This file contains the TMP UT SAR Report Appendix A SAR Probe Validation plots made at 900 and 1800 MHz and a Page 14 change-page to the body of the report.

Company QUALCOMM Inc.	Document No. 80-98846-1	
GS UT SAR REPORT	Issue No: 1	Date July 8, 1999
Equipment GLOBALSTAR GSP 1600	Page Number 14

8 SAR TEST SYSTEM VALIDATION

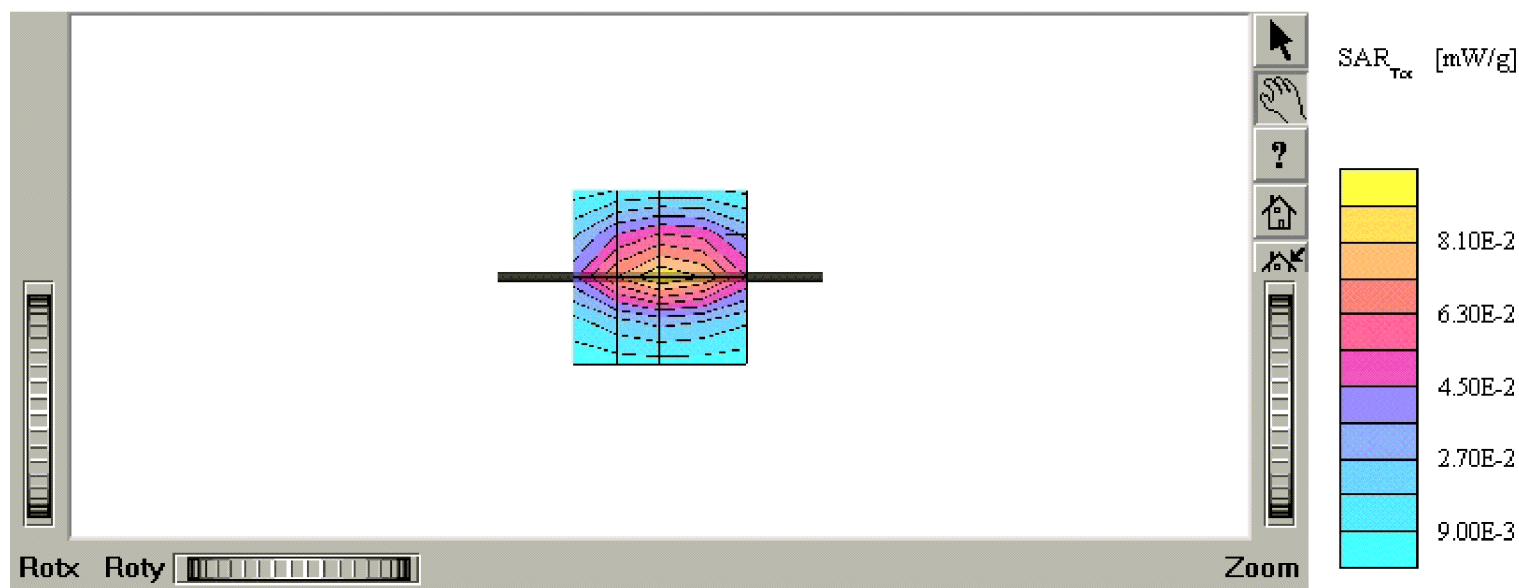
Contrary to what had been stated in the initial release of the SAR Report, the validation testing was performed using a 10 milliwatt test signal power into the calibration dipole, not an amplified 1.0 Watt signal as had been stated. This change page corrects that error.

The 0.01 Watt signal was checked with an HP RF power meter (calibrated to 1800 MHz) several times over a 30 minute period (to eliminate drift by reaching stable temperature), then input to the validation dipole. Then the DASY3 system was put through an automated validation cycle to determine if the correct SAR is measured. The correct SAR for a 1.0 Watt signal was determined by Schmid & Partner to be 39.9 mW/gm for the type D1800V2 dipole, and 9.44 mW/gm for the D900V2 dipole. The corresponding correct SAR values for a 0.01 Watt signal are 0.399 mW/gm for the type D1800V2 dipole and 0.0944 mW/gm for the type D900V2 dipole. These values measured indicate that the system is measuring correctly at these frequencies.
